Service Notice N°: ESN0069 Rev.0

Y028 Graphic User Interface (GUI) rework

Product	K Number	Code Number	Serial Numbers
SPEEDTEC 200C	K14099-1	50328	From P11702xxxxx to P1171001163
SPEEDTEC 200C AUS.	K14099-2	50281	From P11702xxxxx to P1171001163
SPEEDTEC 200C BR.	K14099-3	50317	From P11702xxxxx to P1171001163
SPEEDTEC 215C	K14146-1	50314	From P11702xxxxx to P1171001163
SPEEDTEC 215C AUS.	K14146-2	50324	From P11702xxxxx to P1171001163

Fig. 1.

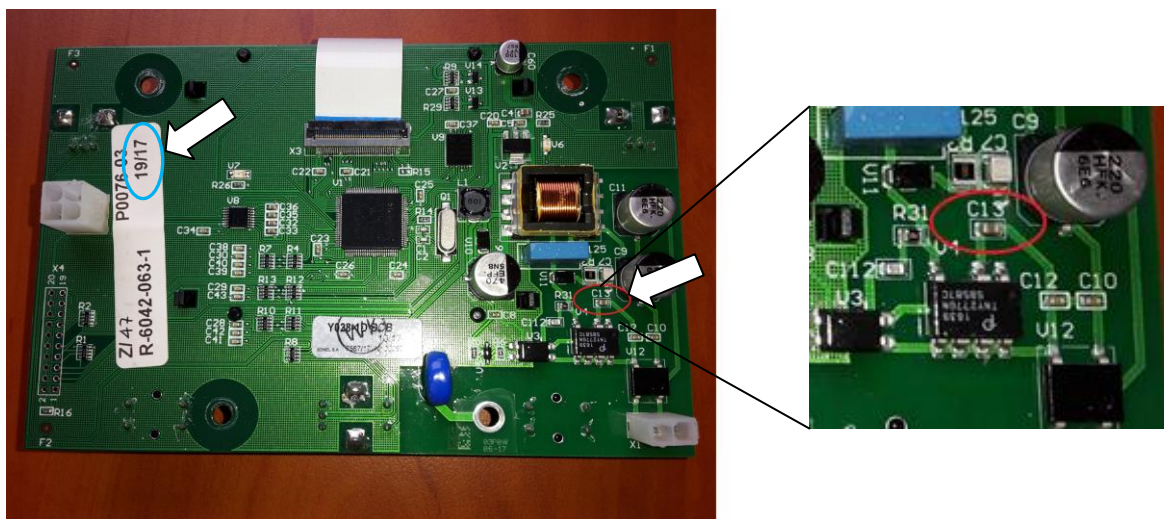
In welders Speedtec 200C and Speedtec 215C with serial numbers from P11702xxxxx to P1171001163 it should be increased the capacitance of C13 capacitor in Y028 GUI module (see red ellipse in Fig.1). The problem can be verified by turning ON the welder and visual check of LCD display. If the LCD display is OFF and dark or blinking then the Y028 PCB GUI module has to be reworked. If the LCD display is ON and it displays standard welder screen, then the Y028 PCB GUI module is good but is also recommended to rework it to prevent a future failure. **Y028 PCB GUI modules with production number greater or equal to 38/17 (see blue ellipse in Fig.1) do not need the rework.**

- The red ellipse indicates the position of the capacitor C13 that has to be replaced.
- The blue ellipse indicated the board production date, PCBs with production dates greater or equal to 38/17 are OK and do not need capacitor rework.

- Ceramic capacitor MLCC SMD; 47uf; 0805; 10V; X5R; 20%.

- a. Remove the varnish from the capacitor C13.
- b. Unsolder the capacitor C13
- c. Remove old tin from pads after C13 capacitor.
- d. Solder the new capacitor 47uF; 10V; X5R; SMD 0805

Capacitor C13 and its surroundings on the board should be painted with DC1-2620, ISOTEMP; ELASTOPLASTIC CONFORMAL COATING.
